File FP-1996-117

Name: Dawn Subdivision – Final Plan – S. of Hawthorne Avenue / E. of 28 Rd.

RESPONSE TO REVIEW COMMENTS

FILE: FP 96-117

Figure 3.25. Headwater Depth for Circular Concrete Pipe Culverts with Inlet Control.

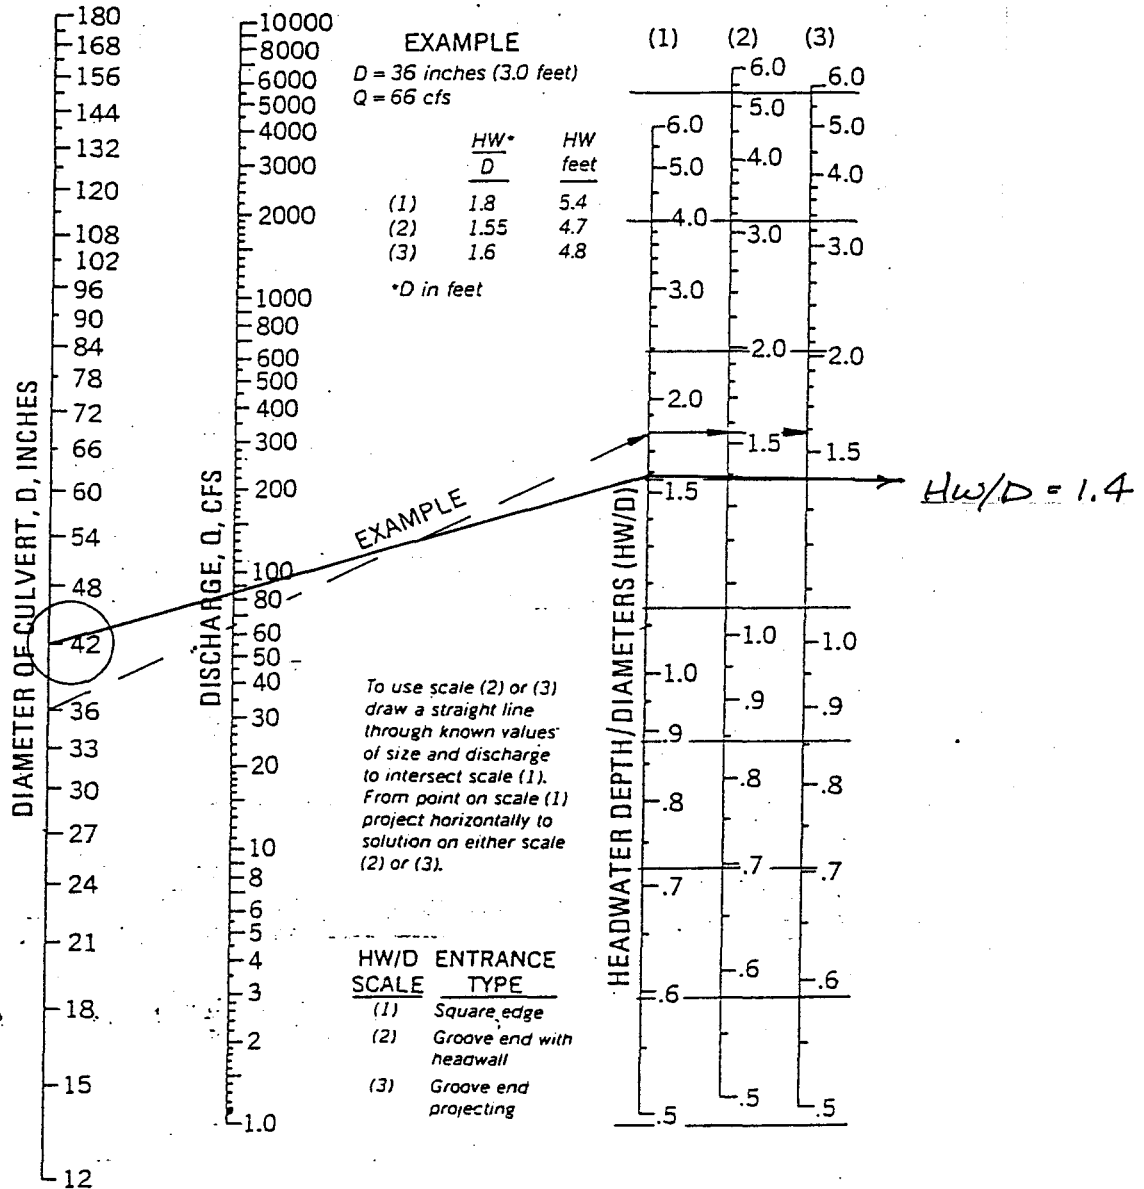
COMMENT #6

5. Utility crossings in the storm sewer profile have been provided.
6. A plan and profile for the proposed irrigation ditch pipe has been provided on the revised grading and drainage plan. Calculations for the sizing of the new pipe were performed and accompany these responses.

18. Improvements for completion of Grand View Drive have been provided on the Grading and Drainage plan. A detail for the pipe crossing under Grand View Drive is also provided on the Grading and Drainage plan. Calculations are provided to verify pipe size and accompany these responses.
